Access Compliance Report

Public Rights-of-Way

Intersection ID: 3845	Main Street: ZIEGLER_LN	Cross Street: N/A	Location: SE
ADA ID: CCD22E674AC5	Ramp Type: BlendTrans1	Initial Pass/Fail: Fail	Overall Compliance: No
Severity Score: 17.5			
Codes/Mitigation Info/Possible Solution		Field Measurements/Component Compliance

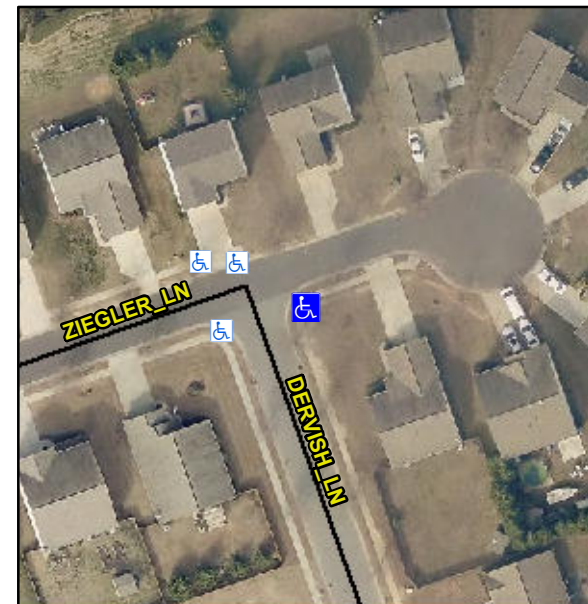
Remove & Replace Curb Ramp With Two New Directional Ramps or Equivalent.

Not Found, R304.5.1
